Application Engineering Design review report	Code: AE-34174
		Rev: 2
		Date: 2022-09-15
		Page: 1/ 6

Design review report

Aim of this document is to describe suggestions and corrections that Telit advises to improve **STF Irrigation "B101AA" (Weather Station)** application that integrates Telit module **LE910S1-EAG**.

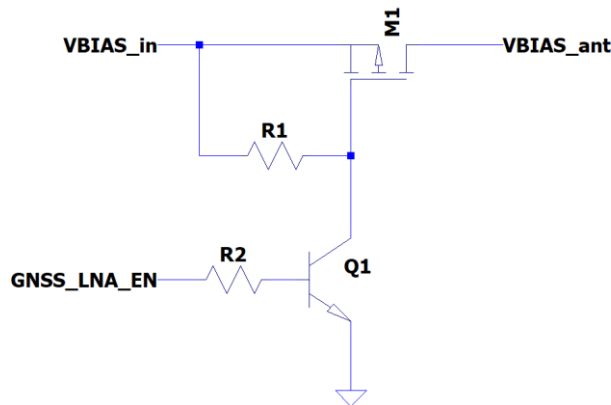
STOP The circuit used to feed the GNSS antenna with DC bias is inappropriate: the DC voltage applied to the antenna (Q4 emitter) is linked to the voltage on the base (less than 1.8V)

rather than VCC. Considering the voltage drop V_{BE} the bias will be less than 1V. We suggest a solution like the one sketched in figure below.

- ⚠ A low-noise design of power supply is a key point for best GNSS receiver performances. For this reason we recommended using a dedicated low-noise source for the DC-bias of the antenna, or at least adding an EMI filter. Using directly VCC is not the best choice.
- i To avoid harmonics we suggest making provision for, on modem board and any other board connected or close to it, 33pF capacitor to GND, placed very close to component and on its same path and layer, in the following cases only if those components are not shielded:
 - o Power Sources and signals on I/O connectors
 - o On power supply input PADs
 - o On power supply output PADs
 - o Diodes in forward conduction, like LEDs, on anode and/or cathodes if not directly tied to a power net
 - o Transistor bases, phototransistors and opto-isolator
